UNITED STATES PATENT AND TRADEMARK OFFICE

APPLICATION NO.	FILING DATE	FIRST NAMED INVENTOR	ATTORNEY DOCKET NO.	CONFIRMATION NO.
10/748,943	12/29/2003	Neil Keegstra	1122-8	7887
23869	7590	01/23/2006	EXAMINER	
HOFFMANN & BARON, LLP			RADI, JOHN A	
6900 JERICHO TURNPIKE			ART UNIT	
SYOSSET, NY 11791			PAPER NUMBER

Office Action Summary	Application No. 10/748,943	Applicant(s) KEEGSTRA ET AL.	
	Examiner John A. Radi	Art Unit 3641

DETAILED ACTION

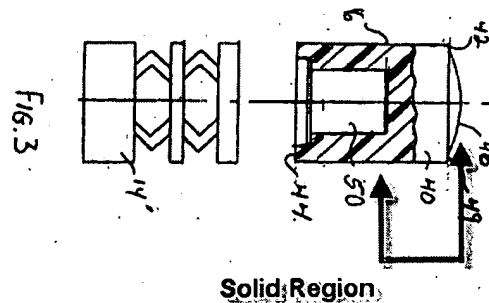
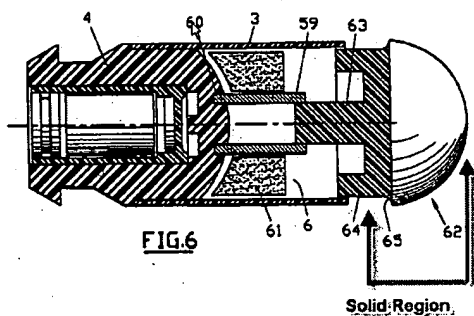
With regard to the argument that Tougeron does not disclose a weight-forward condition, the examiner believes that in Figure 6 it is self-evident that the projectile shifts into a weight-forward situation. When the mass of the nose of the projectile (62) shifts forward, it is inherent that the center of gravity of the projectile moves forward into a weight-forward configuration.

The examiner disagrees with regard to the argument that the nose portion of Tougerons is designed to contain liquid and is therefore not solid. Tougeron's nose portion is solid in the same way that applicant's invention is solid – see applicant's drawings figures 2 and 3 and Tougeron figures 4-6. Examiner defines the nose region of the projectile being from the forward shoulder of the inside cavity (Tougeron: 42, 64) to the tip of the dome.

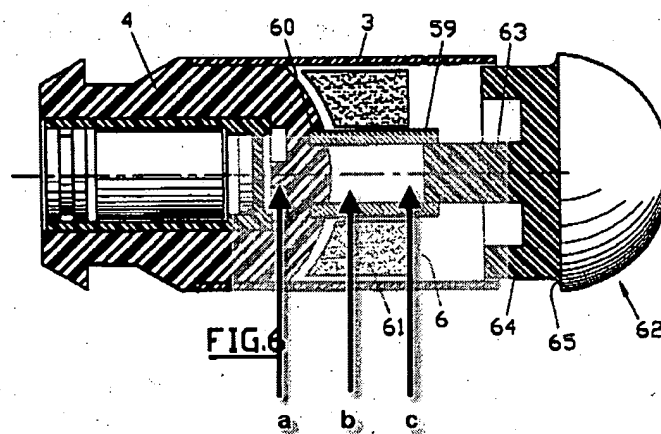
Examiner disagrees that the cavity and motor portions of Tougeron don't bias the weight of the projectile forward. The motor cavity (5) is filled with a propellant and is empty after the projectile is fired, thereby initially moving the center of gravity forward from position "a" to "b." After the nose region of the projectile expands further forward, the center of gravity further moves forward from position "b" to "c."

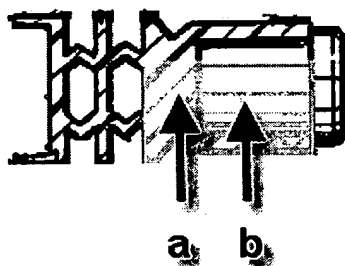
In response to applicant's argument that the unitary seal/wad of Knoster is not a projectile, applicant is directed to Knoster figure 10 and associated description (col. 2 line 57) which asserts that the sabot pressure wad impacts the target.

In response to applicant's argument that the hollow region of Knoster is not dome topped or forward weighted, the examiner respectfully disagrees. The projectile disclosed by Knoster includes the unitary pressure wad/seal (12) and the payload (16) which rests inside the hollow cavity. Once fired, the hollow portions of the wad (28) combined with the projectile's mass create a situation in which the projectile is forward weighted (the center of gravity "b" is forward of the geometric center "a").
